PCN #: 2590

PCN Title: Qualification of Additional Clip Bonding, Lead Frame Structure (Matrix) and Mold Compound for Select Automotive Products

**PRODUCT CHANGE NOTICE****PCN-2590 REV1**

**Figure 1: Comparison of SMA Package Construction for SKY and SBR products**

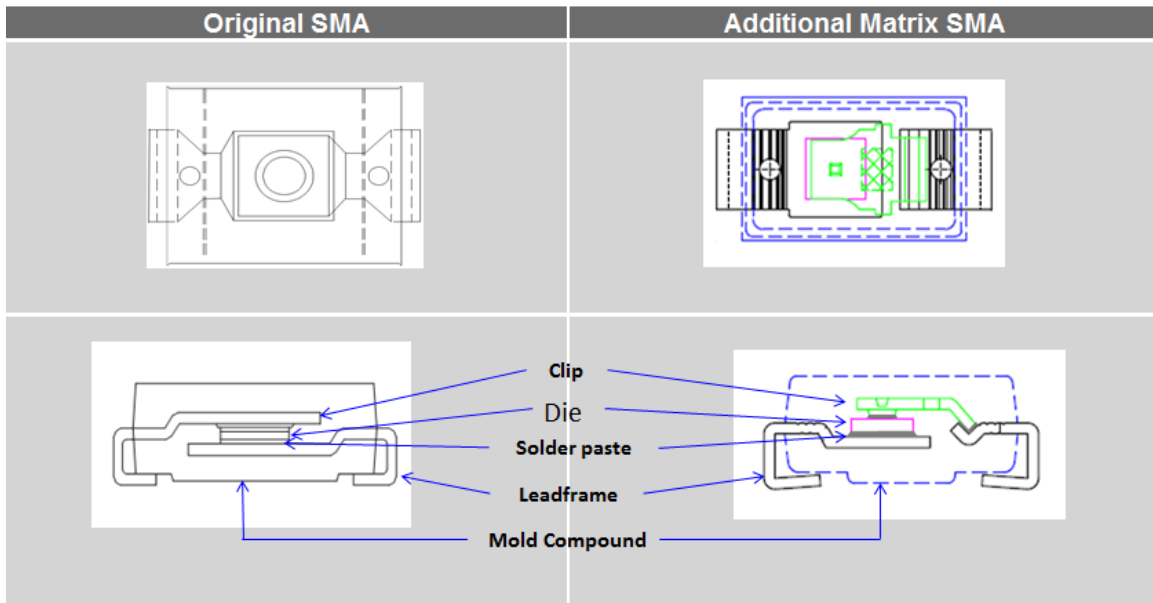
Notification Date:	Implementation Date:	Product Family:	Change Type:	PCN #:
1 June, 2022	1 September, 2022	Discrete - Automotive	Clip Bond, Lead Frame, Mold Compound	<b>2590</b>
<b>TITLE</b>				
Qualification of Additional Clip Bonding, Lead Frame Structure (Matrix) and Mold Compound for Select Automotive Products				
<b>DESCRIPTION OF CHANGE</b>				
<p>This PCN is being issued to notify customers that in order to assure continuity of supply and to improve assembly manufacturability, Diodes Incorporated has qualified additional clip bonding, lead frame structure (Matrix), and mold compound at Diodes subcontractor Eris Technology Corp. (ERIS) in Taoyuan City, Taiwan for select Automotive products.</p> <p>Full electrical characterization and high reliability testing has been completed on representative part numbers to ensure no change to device functionality or electrical specifications in the datasheet. Refer to the attached qualification report embedded in this file (to view, download this PCN file then open it with a PDF viewer to see the attached qual report).</p> <p>There will be no change to the Form, Fit or Function of affected products unless specifically indicated (see figures 1 – 5).</p>

<b>IMPACT</b>				
No change in datasheet parameters and product performance				
<b>PRODUCTS AFFECTED</b>				
Please refer to Table 1 for the affected automotive products and Figures for comparison of package construction below				
<b>WEB LINKS</b>				
<b>Manufacturer's Notice:</b>	<a href="https://www.diodes.com/quality/product-change-notices/diodes-product-change-notices/">https://www.diodes.com/quality/product-change-notices/diodes-product-change-notices/</a>			
<b>For More Information Contact:</b>	<a href="https://www.diodes.com/about/contact-us/contact-sales/">https://www.diodes.com/about/contact-us/contact-sales/</a>			
<b>Data Sheet:</b>	<a href="https://www.diodes.com/catalog/">https://www.diodes.com/catalog/</a>			
<b>DISCLAIMER</b>				
<b>Unless a Diodes Incorporated Sales representative is contacted in writing within 30 days of the posting of this notice, all changes described in this announcement are considered approved.</b>
